RE: Memorial Park Master Plan

Tillsonburg	Report Title	Memorial Park Master Plan
	Report No.	PRA 18-01
	Author	Mel Getty – Chair, Parks & Recreation Advisory
	Meeting Type	Council Meeting
	Council Date	January 8, 2018
	Attachments	 Master Plan for Memorial Park & Lake Lisgar – November 2017

Master Plan For Memorial Park & Lake Lisgar Tillsonburg, Ontario

Prepared by Memorial Park Revitalization Project Subcommittee Tillsonburg, Ontario

Master Plan Recommended Sportsfield Layout

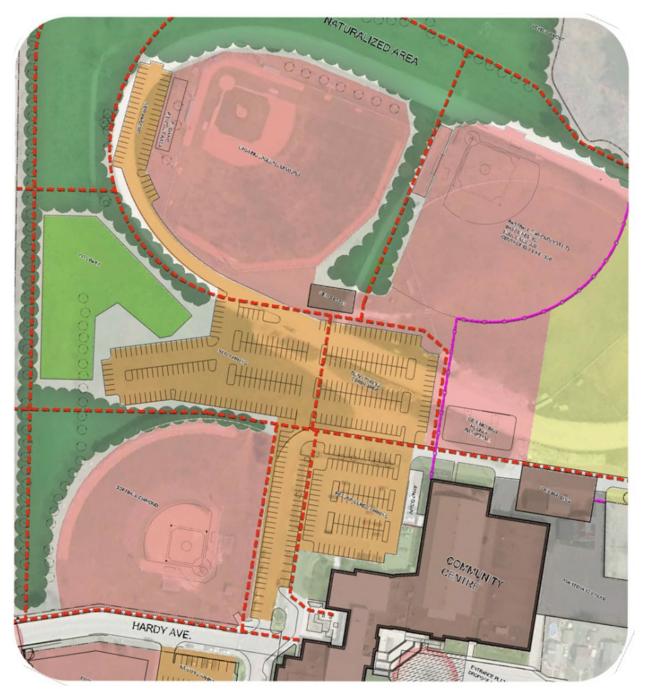
CMP: Remove the ball diamond at the south end of the race track and replace with a new, smaller diamond (Little League size with grass infield) in the space between the current softball and hardball diamonds.

CMP: Expand the existing softball diamond by moving the clay infield and bleachers closer to the corner of Hardy Ave., and creating a larger outfield area.

CMP: Remove the existing race track and horse barn to make space for other uses.

CMP: Add a new centralized field house between the three ball diamonds. The building can include change rooms, offices, washrooms, storage, and a concession stand.

Master Plan Recommendation: Altered. Rebuild and reposition existing hardball diamond #1 as a full-size (330' @ centerfield) with a clay infield and permanent pitcher's mound to accommodate all ages and abilities.

Master Plan Recommendation: Abandoned.

Master Plan Recommendation: Adopted. This work has been partially completed. The south end of the track has been removed.

Master Plan Recommendation: Altered. This element has been repositioned in the Master Plan to reflect the recommended change in diamond layout.

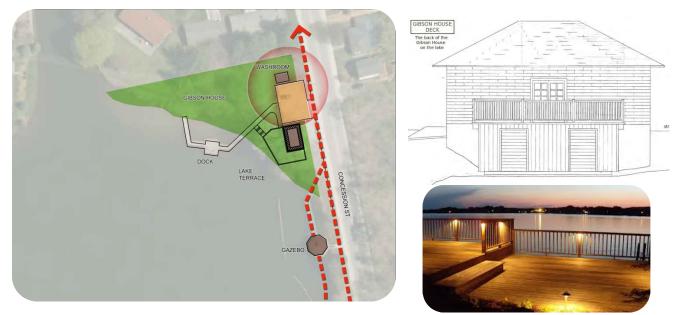
CMP: Add washroom facilities, either using a semi-permanent, portable trailer structure, or a permanent structure with composting toilets.

CMP: Consider operating a nature interpretation and welcome centre at this location.

CMP: Add a cantilevered deck or terrace on the back of Gibson House, overlooking the Lake.

Master Plan Recommendation: Adopted. Development on this site should include improved washroom facilities.

Master Plan Recommendation: Tabled.

Master Plan Recommendation: Altered. Boathouse storage should be incorporated under elevated deck structure.

Delevan Crescent pedestrian bridge entrance

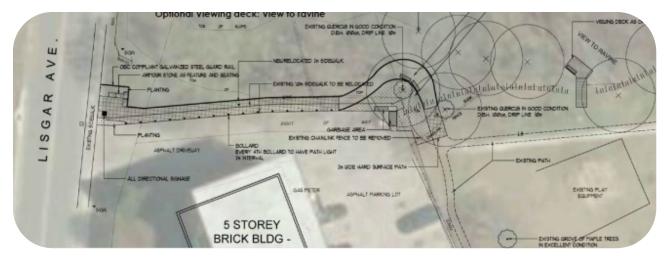
CMP: Use landscaping, signage, and paved surfacing to create a welcoming and more visible pedestrian entrance at the bridge access point on Delevan Crescent.

Master Plan Recommendation: Adopted. A complete design has been prepared.
